PLANNING COMMISSION MEETING

Administrative Staff Report

Kwik Trip Inc.

Site Plan & Architectural Review

4) Parking

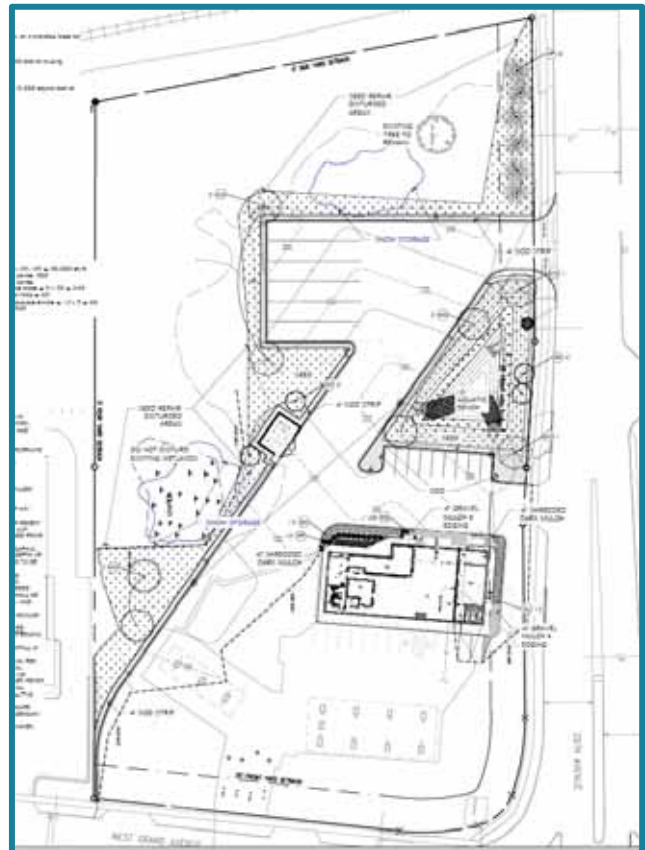
Analysis: The use requires 1 space for each 300 square feet of gross floor area, for a total of 21 parking spaces required and one ADA approved accessible space required.] There are 20 parking spaces provided and 2 ADA approved accessible parking spaces. Six tractor-trailer parking spaces are also proposed.

Findings: The 6 tractor trailer spaces bring non-ADA parking space total to 26. This exceeds the required amount of parking by more than 15 percent. The Planning Commission can grant a special exception to exceed the minimum number of spaces by more than 15 percent when they determine that additional spaces are needed for the particular use or location. Staff would recommend that the Plan Commission approve the increase in parking based on the operational needs of this particular business/the use.

Additionally, with the addition of new parking, there are 13 parking spaces located in front of the principal building and 15 behind the front plane of the principal building. The Planning Commission can grant a Special Exception to allow more than 35% and up to 50% of the parking in front of a principal building. Staff is recommending that in this case it be granted due to the existing size and configuration of the property and nature of operation of a vehicle fuel station.

6) Architectural Review

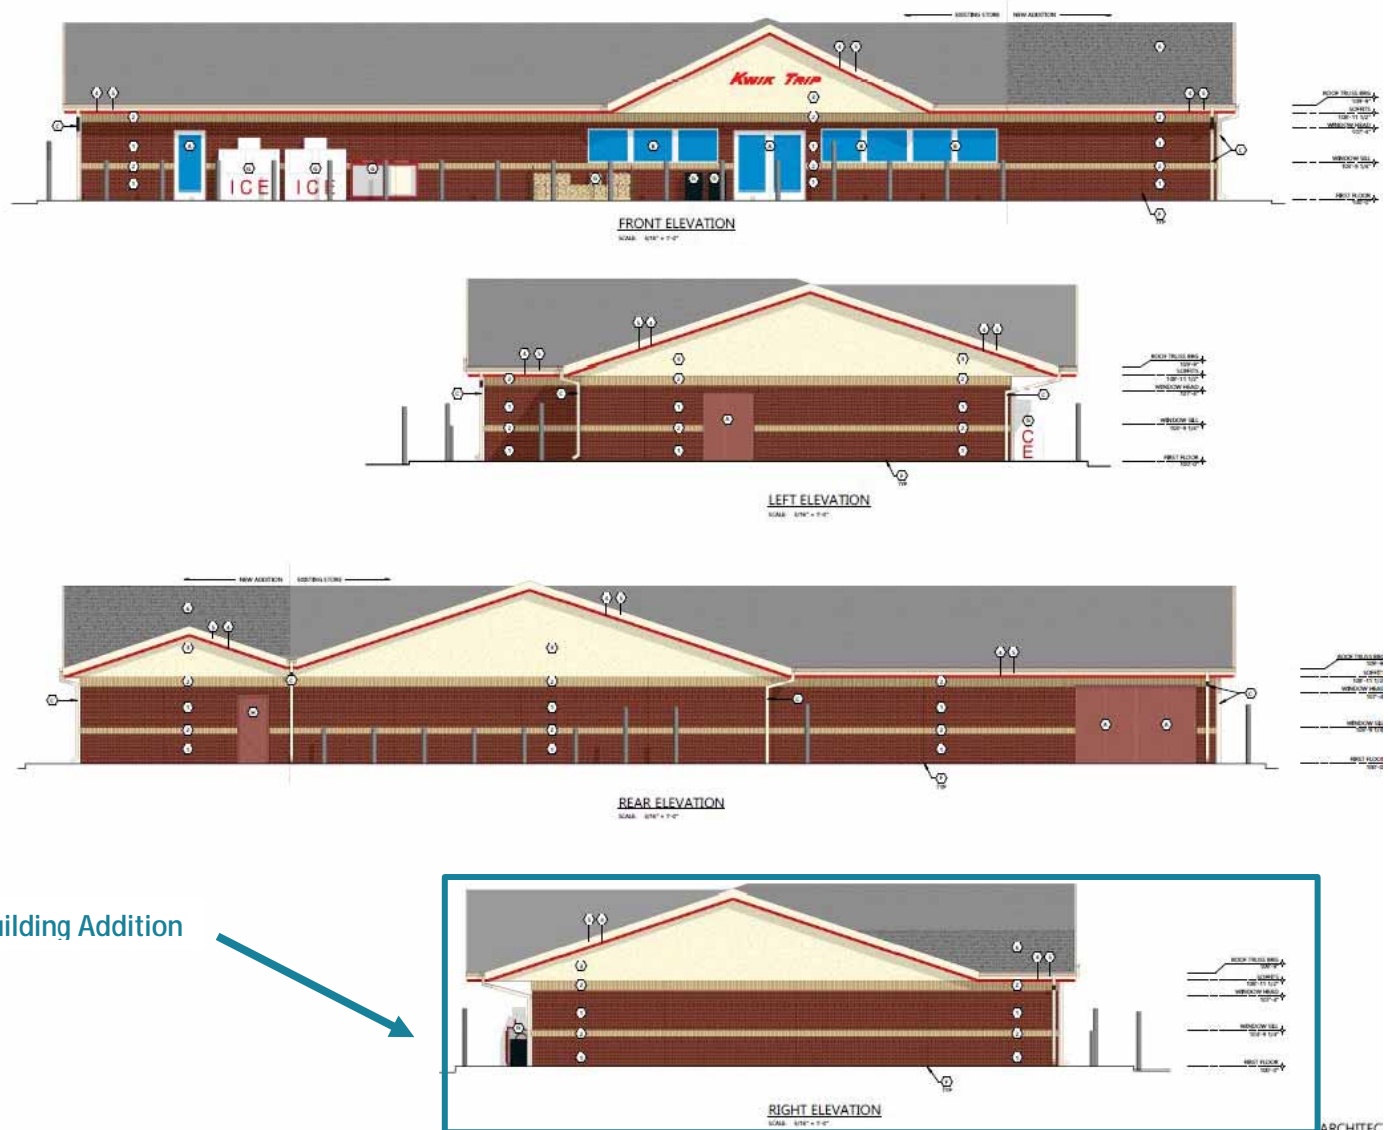
Analysis: Elevations have been submitted, showing the building façade. The original building consists primarily of cream colored vinyl siding with red brick wainscoting. A façade improvement is proposed to the existing building and will be comprised mainly of red brick with tan brick and EIFS accents. Red aluminum fascia accents will be added that match the Kwik Trip branding. The proposed building addition is proposed to be constructed with matching red brick and complimentary accents. The roofline is also consistent with the existing structure.

Findings: The proposed façade improvement and matching building addition provide a substantial enhancement to what is existing. From an architectural standpoint the addition ties in very well to the existing building both in terms of materials and in terms of massing, scale, and design.

LANDSCAPE PLAN
PARKING / KITCHEN ADDITION 310
WASCOW RUN, RAPID E, WASCOW RUN

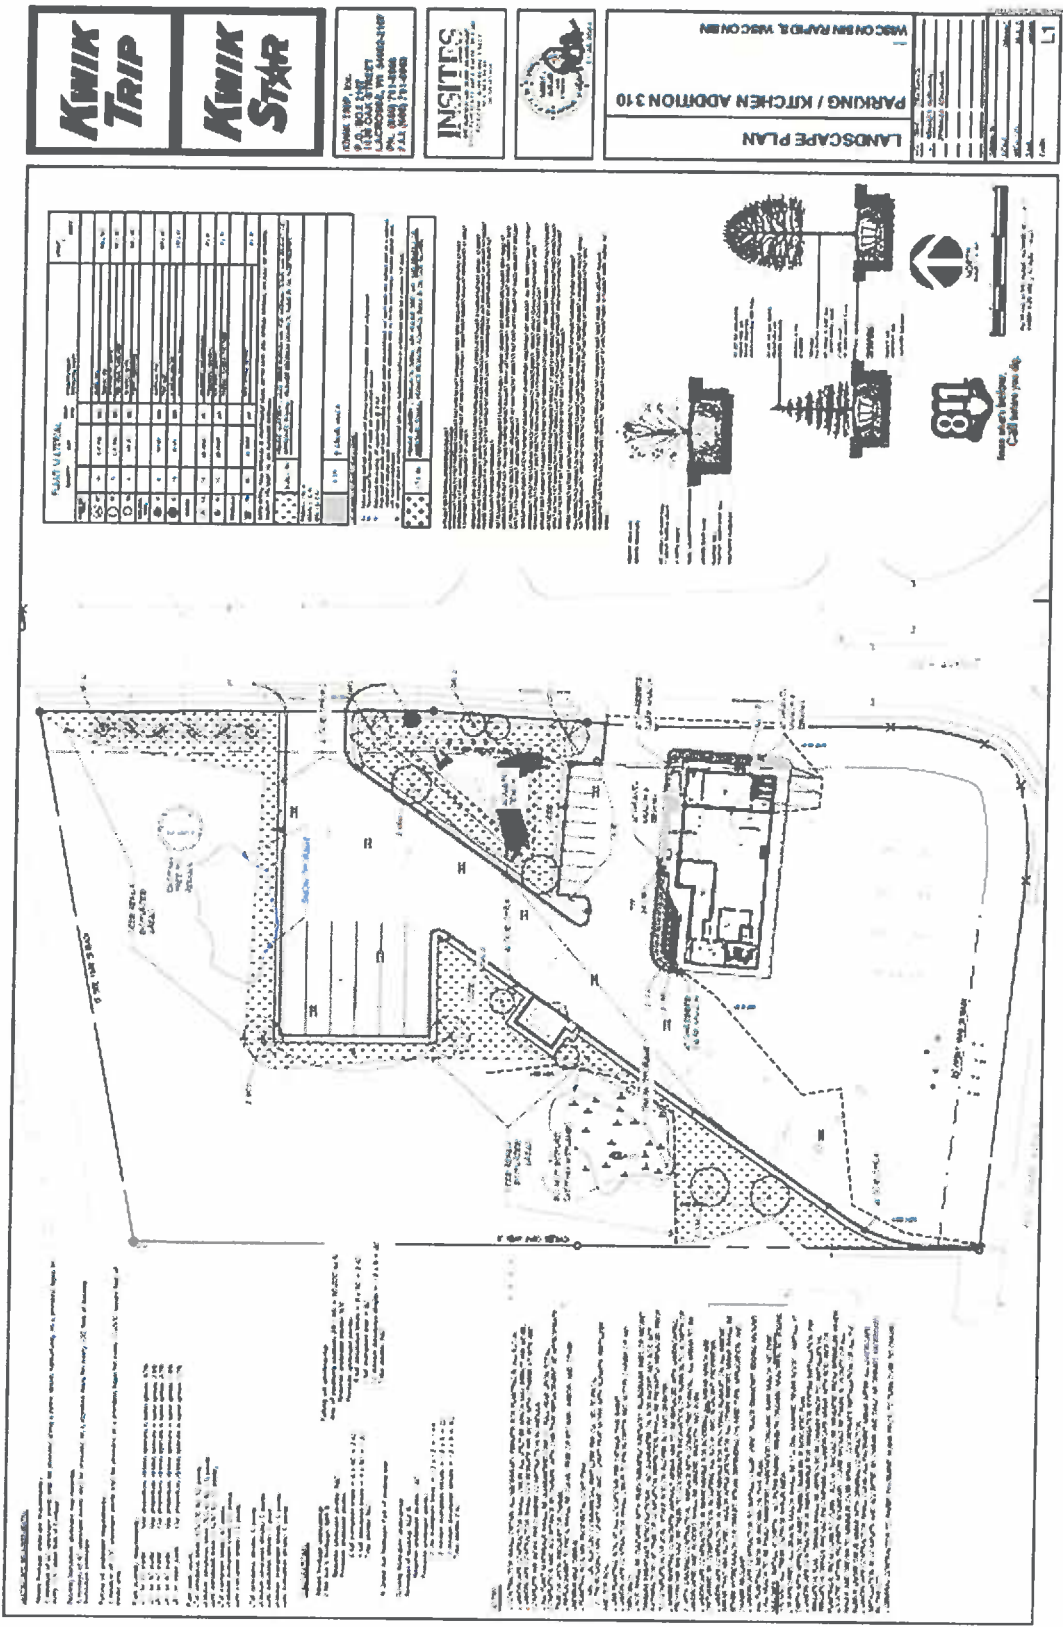
The applicant is proposing a nice mix of plantings that nearly meet the required point minimums and allocations. The one exception is the allocation of frontage points. This is a relatively minor modification that can be easily addressed, and a condition has been added requiring a revised landscape plan.

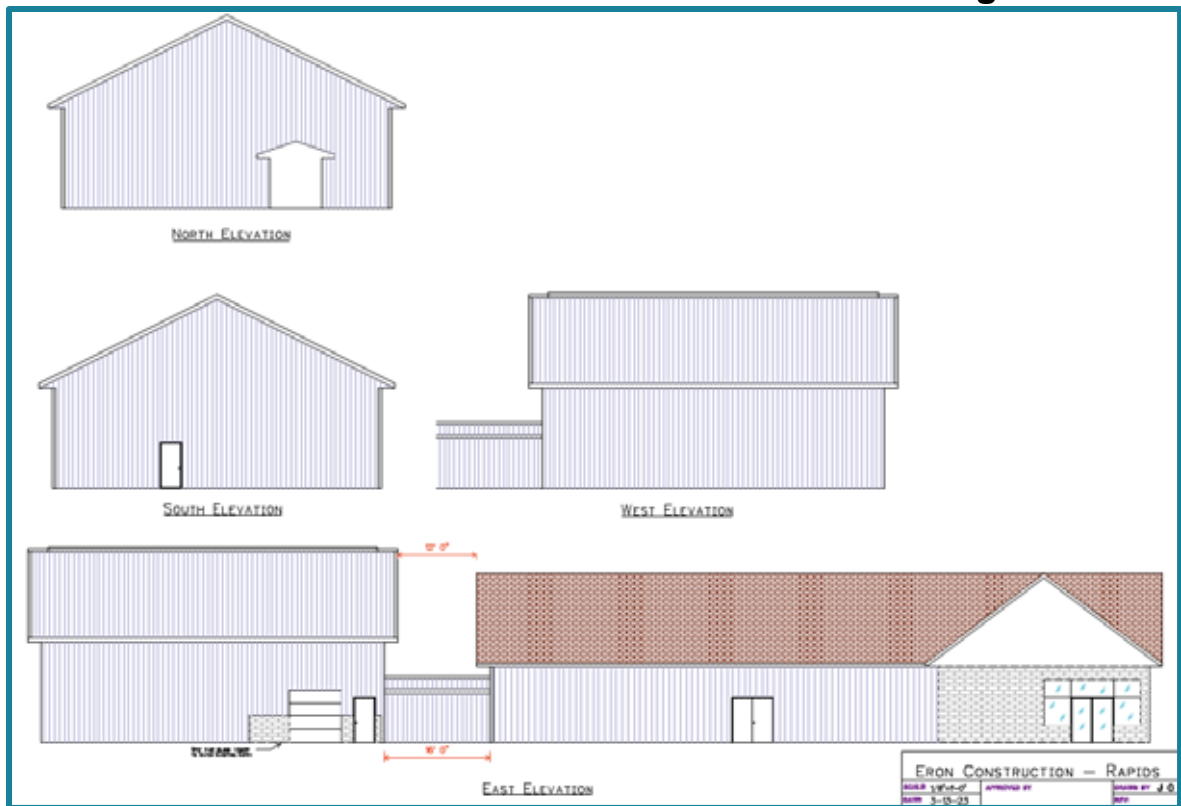
Findings: The applicant is proposing three medium evergreen trees and two low evergreen trees for a total of 84 points which meet the landscaping points requirement. However, only low trees and shrubs are permitted to meet foundation points and must be planted near the building foundation. Therefore, an updated landscaping plan is required to be submitted.

PLOT PLAN
SCALE: 1" = 20'

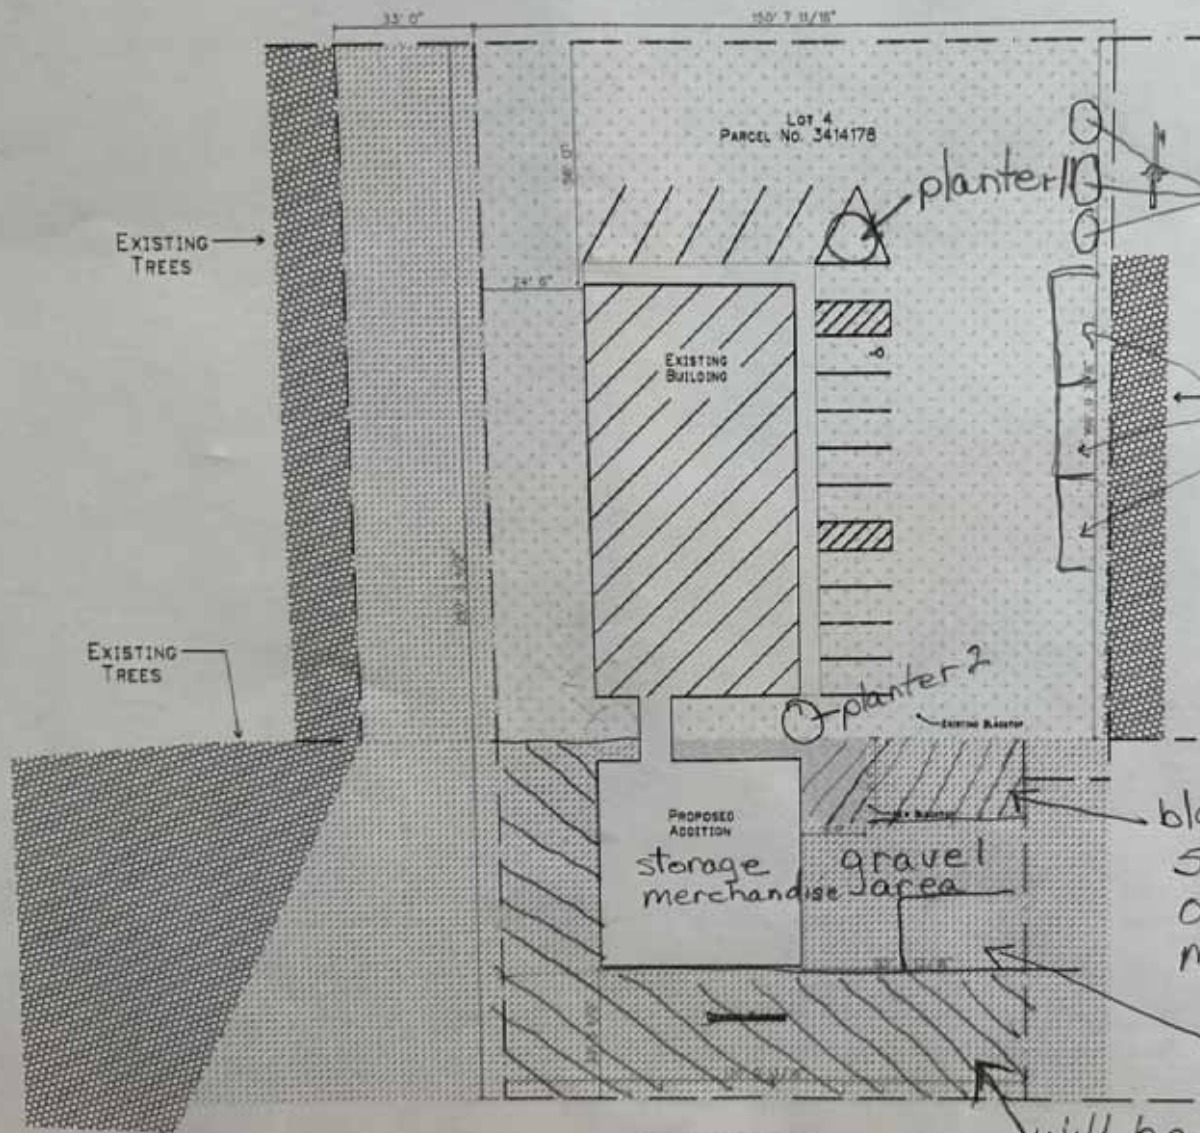
Findings: The two points of access provide adequate access to the parking lot. Circulation on site will function much the same as it has historically, with truck traffic driving to the southeast corner of site to the newly hardscaped area for parts delivery. The western most driveway is gravel and should be paved for vehicular use.
